TSB160123

Transit Bus Belt Squeal with EMP450 Alternator

Figure 1, Remove Items 1 Through 8.

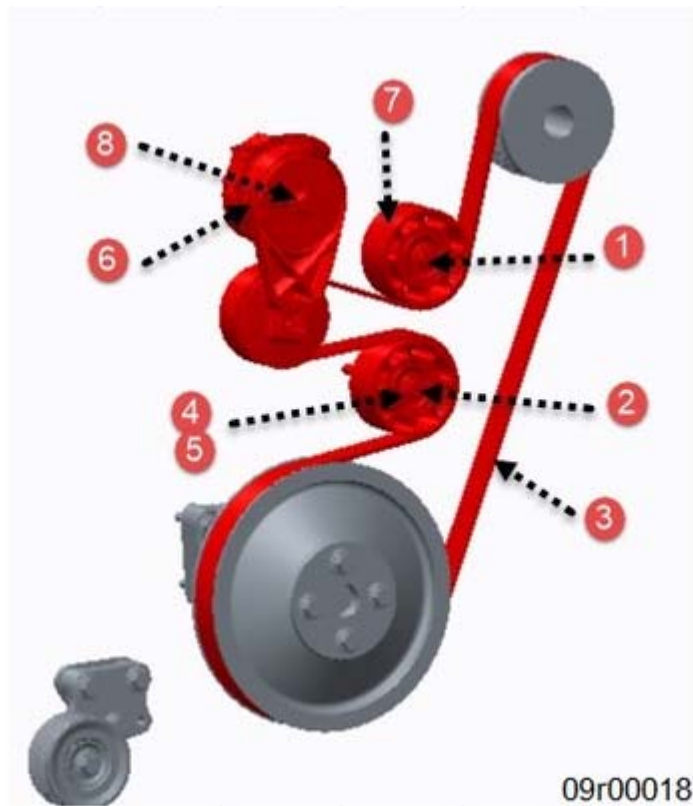
Remove components from front end accessory drive. Reference Figure 1 and Table 2.

Figure 2, Remove Items 1 and 2.

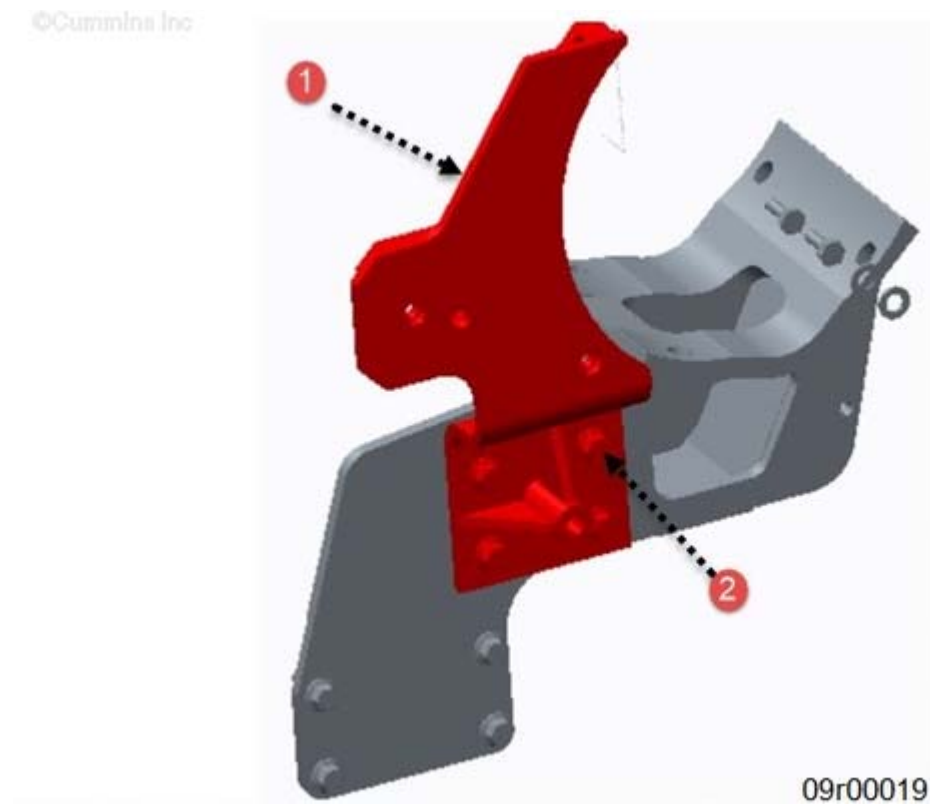
Remove idler pulley bracket and capscrews from alternator bracket. Reference Figure 2 and Table 3.

Figure 3, Install Items 1 and 2.

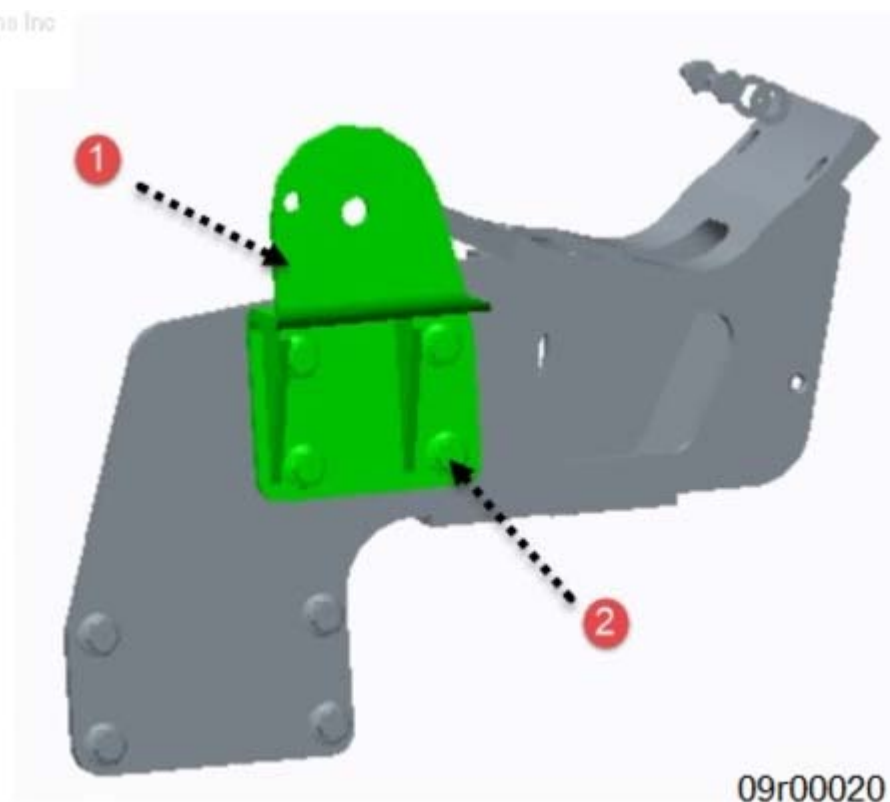
Install Engineered Machined Products bracket and capscrews. Reference Figure 3 and Table 4.

65 N•m [47.9 ft-lb]

Figure 4, Install Items 1 through 3.

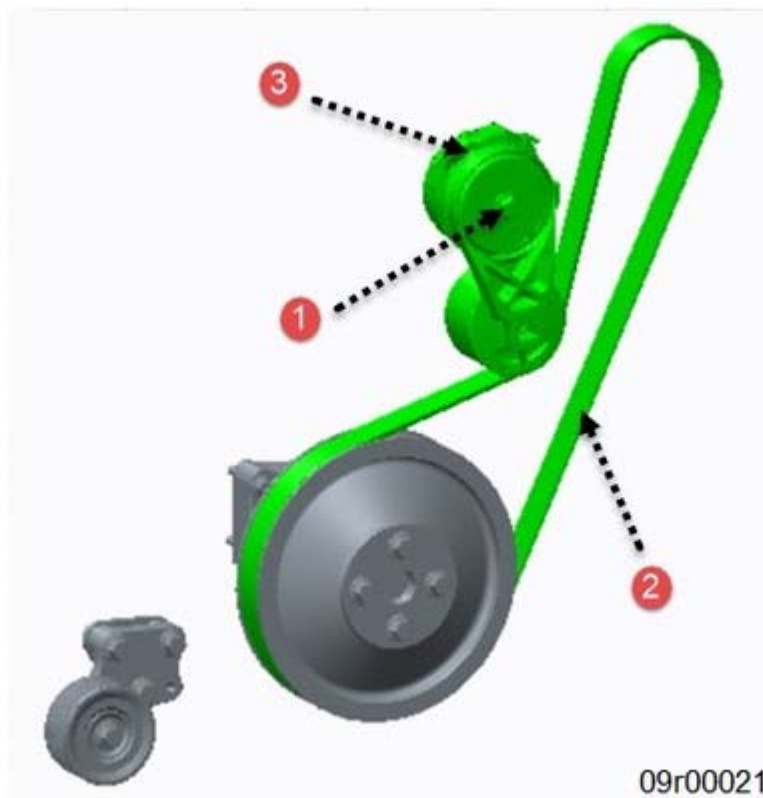
Install belt tensioner, belt, and capscrew. Reference Figure 4 and Table 5.

50 N•m [36.8 ft-lb]
